MUSKRAT FALLS TRANSMISSION LINE REVIEW

October 12, 2016

The Consumer Advocate NL

Figure 2 – Typical Guyed-Vee Transmission Tower

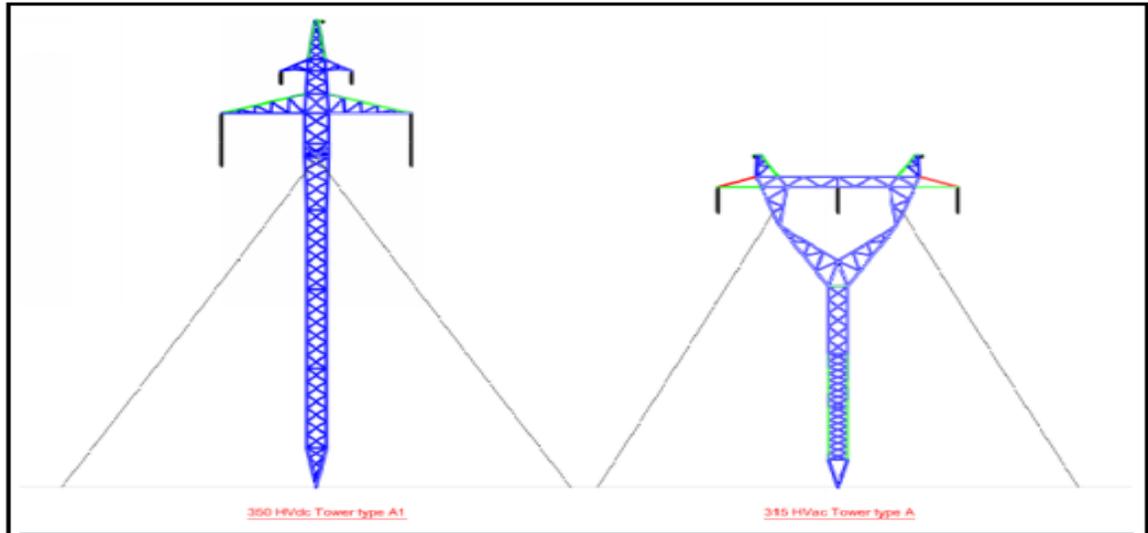
- 1 • Guyed-vee structure design cannot be properly validated with the lack of
2 testing documentation, longitudinal design criteria, and cascade event
3 control. The remoteness of this line presents a concern with a susceptibility
4 for a broken guy wire causing a possible cascading event and an extended
5 outage.
